COUNCIL ASSESSMENT REPORT

SYDNEY NORTH PLANNING PANEL

PANEL REFERENCE & DA NUMBER	PPSSNH-682 and MOD2025/0381
PROPOSAL	Modification of Development Consent DA2015/0901 granted for demolition works, alterations and additions to the existing pub, construction of hotel or motel accommodation and retail liquor store
ADDRESS	39 Frenchs Forest Road East FRENCHS FOREST
APPLICANT	Endeavour Group Limited
OWNER	Australian Leisure and Hospitality Group Pty Ltd
DA LODGEMENT DATE	14.7.2025
APPLICATION TYPE	Modification Application (s4.56 of EPA Act, 1979)
REGIONALLY SIGNIFICANT CRITERIA	<i>State Environmental Planning Policy (Planning Systems) 2021</i> declares the proposal to be regionally significant development
CIV	\$57,076,611 (excluding GST)
CLAUSE 4.6 REQUESTS	Nil
KEY SEPP/LEP	• State Environmental Planning Policy (Planning Systems) 2021 • State Environmental Planning Policy (Sustainable Buildings) 2022 • State Environmental Planning Policy (Transport and Infrastructure) 2021 • State Environmental Planning Policy (Biodiversity and Conservation) 2021 • State Environmental Planning Policy (Resilience and Hazards) 2021 • State Environmental Planning Policy (Industry and Employment) 2021 • W

Figure 12 - Signage in Modified Scheme (Deleted by Applicant)

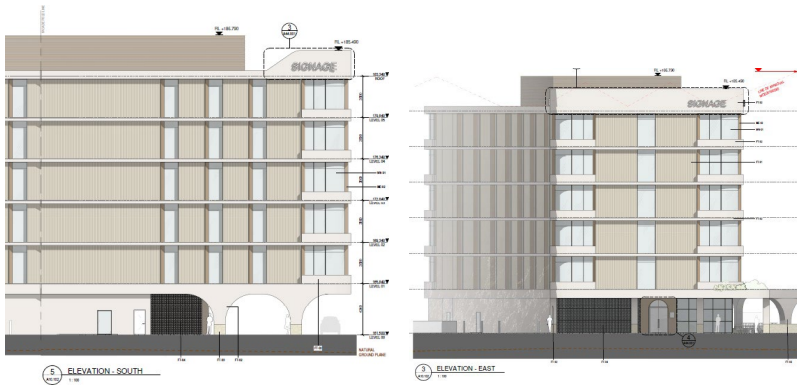
However, the planning assessment raised concerns in relation to the location and impact the proposed signage above street level would have upon the general amenity of the area, as there are no other buildings with high-level signage along the frontage to both streets. It is not considered appropriate to have rooftop signage in the locality, given the location on a ridgetop with high visibility for many kilometers around, nor is the sign required for wayfinding for vehicles on Warringah Road.

Based on advice from Council, the applicant elected to remove the signage from the application and will lodge a separate DA for signage.
